ACOUSTILOG^{INC.}

December 5, 2011

Ms. Donna Lennard
Il Buco Vineria
53 Great Jones Street
New York, NY 10012

Re: Rooftop HVAC Noise

PURE TONE AT 48 BOND

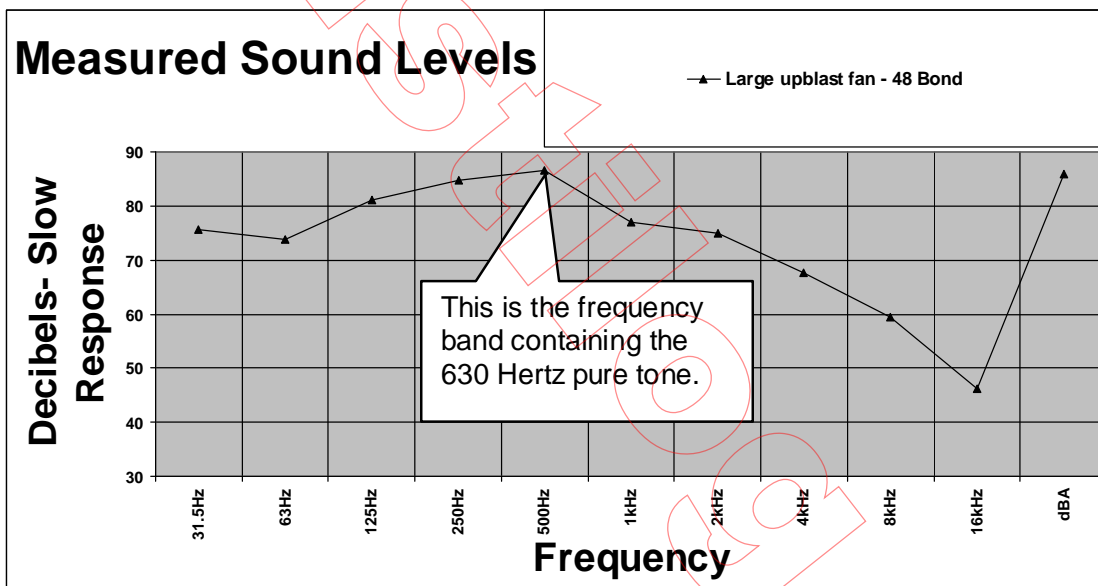
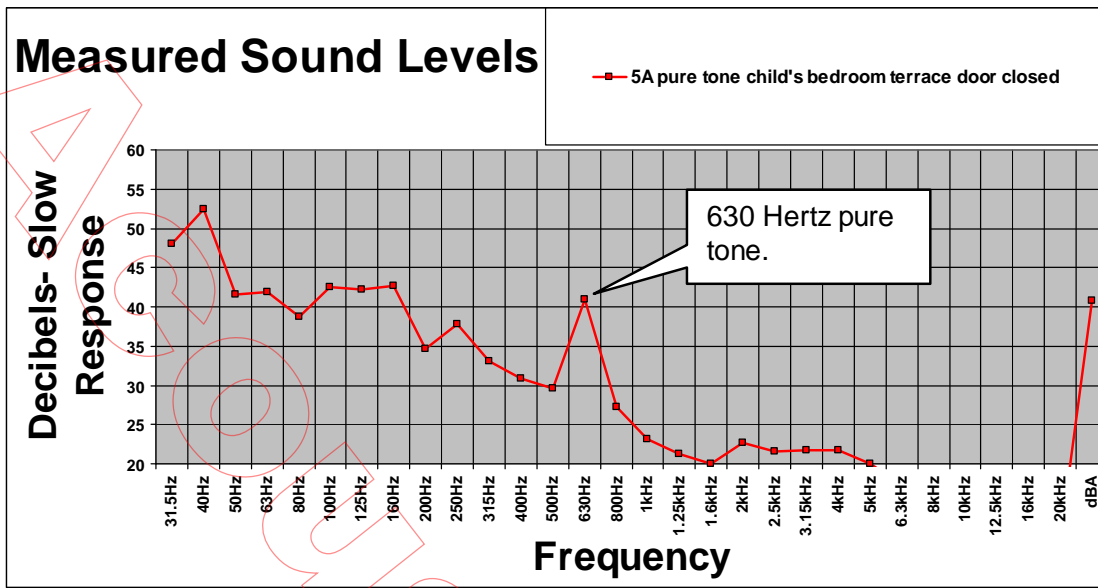
I measured sound in Apartment 5A at 48 Bond. The resident said that the problem is a high whining sound coming from the silver box with the visible fans. She led me into the son's room where a pure tone was clearly heard even with the terrace door shut. The same sound, with a slightly different character, was heard in the master bedroom. The resident also complained that the fans were not turned off at night so she suffers from the tones all the time.

I noticed that when the fans were turning they made no audible noise; I pointed this out to the resident who thought that both fans were off when one was clearly spinning. She then saw this herself. However, the pure tone was heard with the fans running or not. The pure tone consisted of a 630 Hertz continuous "ringing" or "humming" sound, measuring as loud as 41 decibels in the son's bedroom.

630 Hertz is best described as a midrange sound; this pure tone sounds like an owl hooting except that it does not stop. A pure tone is not a natural sound, like ocean waves, rainfall, or wind. While such sounds consist of a range of frequencies, a pure tone consists mostly of a single frequency or pitch, like a fog horn or a machine hum. A pure tone is unnatural, attention-getting, and penetrating.

Because the sound was from a pure tone source, it varies up and down in level depending on where one measures it. This is due to the existence of "standing waves", a series of high and low loudness locations. The sound bounces back and forth in the room and either adds to or subtracts from the same sound bouncing in another direction. In some places in a room, the combined waves can cancel each other out, while in other locations the sound can be quite strong. Outdoors, pure tones are hard to localize. See the graphs below.

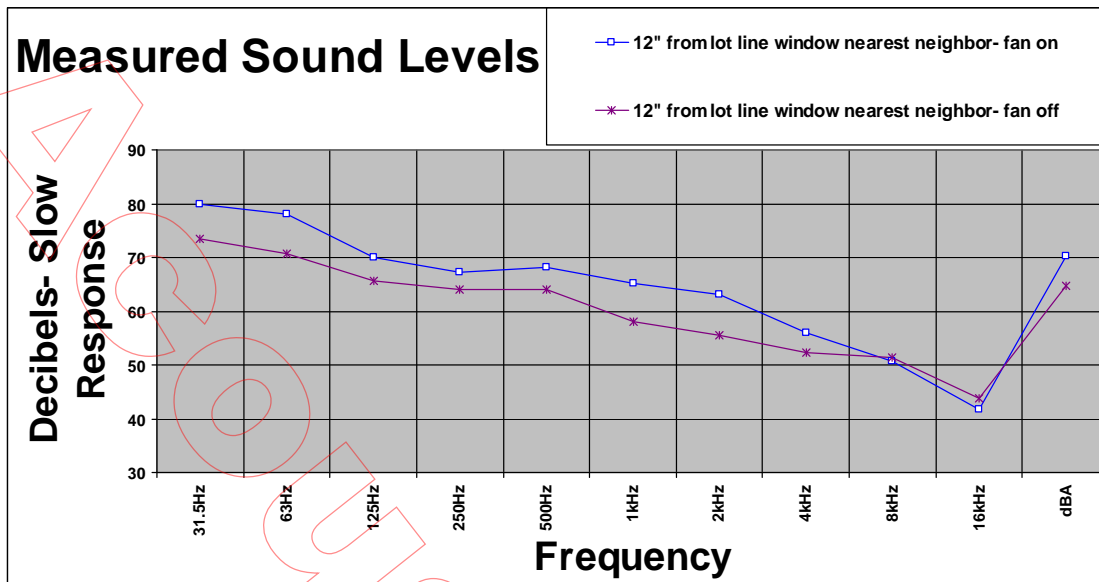
The large exhaust fan now has an enclosure. The enclosure has been built but not according to my specifications. The inside faces are all supposed to have exposed fiberglass insulation. Instead, concrete board was used on the inside as well as the outside, so the fiberglass cannot absorb any of the noise in the enclosure. Take the inner concrete board off.

There is an issue about the height of the enclosure; if necessary lower the box but do not let it touch the fan gooseneck duct.

Since we now know that the lot line window is the DEP preferred test location, I suggest that you modify the box slightly by making the discharge opening point west instead of north. This opening will therefore face away from the lot line window. There would also be less discharge in the direction of the air conditioners and the east makeup air intake. This opening should be at least as large as the actual fan duct opening itself, approximately 14 x 22. Install the inner gooseneck as planned but add a 45 degree "scoop" or angle of inner fiberglass to direct the exhaust west toward the opening. Cover the 2" fiberglass throughout the inside of the enclosure with Armstrong 5/8" thick ceiling tile, with the white side facing the airstream. Use any of the following types, available from Home Depot:

The graph above shows that the fan's noise level is 70 dBA outside the window, and 65 dBA when the fan is off. Accounting for the drop in sound when the window is opened and sound is measured 3 feet inside the opening, I predict that the sound level from the fan is now approximately 60 dBA, still far in excess of the Code limits. However, the actual level depends upon the configuration of the fan enclosure, which has changed in the last several days. Although it is not known whether the noise level I measured today is the actual level measured by the DEP inspector, the soundproofing recommendations which I am providing will greatly lower the sound level.

- 403 esprit 10 panels 30 sq.' 2x4 5/8
- 404 pebble 10 panels 30 sq.' 2x4 5/8
- 421 shasta 10 panels 30 sq.' 2x4 5/8

When the panels get too dirty, replace them. They can be attached with pins or they can be covered with porous screening to hold them in place against the airflow.

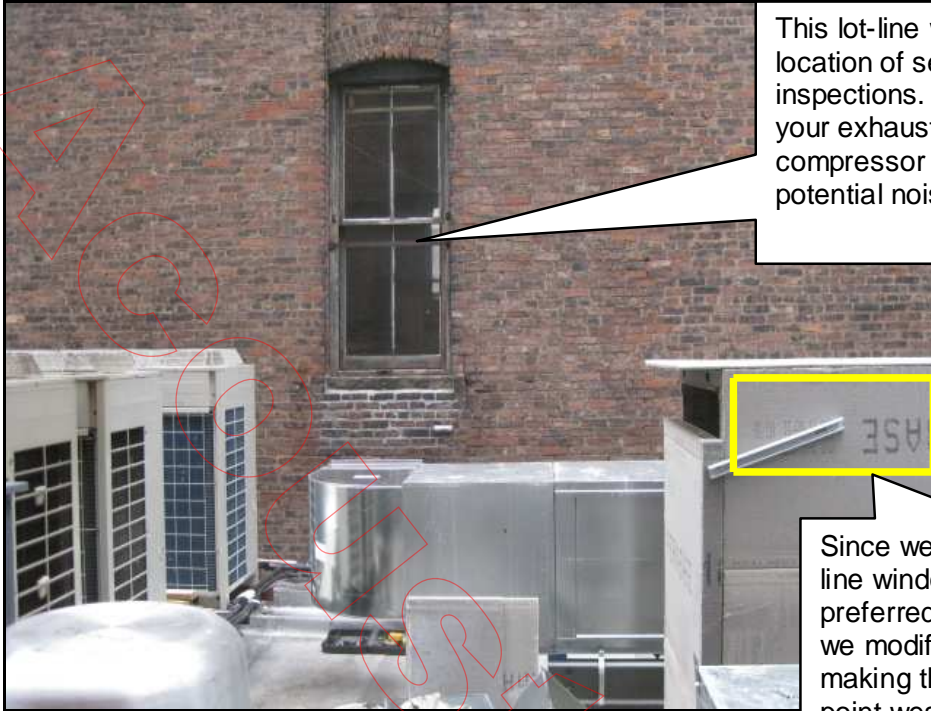
These fans belong to 48 Bond. The annoying 630 Hertz pure tone has been coming from this largest upblast fan on the left, and not from the equipment on your roof.

Not only are the fans belonging to 48 Bond a source of noise, but there are other visible grills that lead to other noise sources. These sources have not yet been investigated.

The owners of the 48 Bond fans should fix this problem. My simple suggestion is to have them call their own mechanical contractors to eliminate the noise, which is probably due to a bad bearing in the fan. I can design a solution for them that works if their contractor cannot.
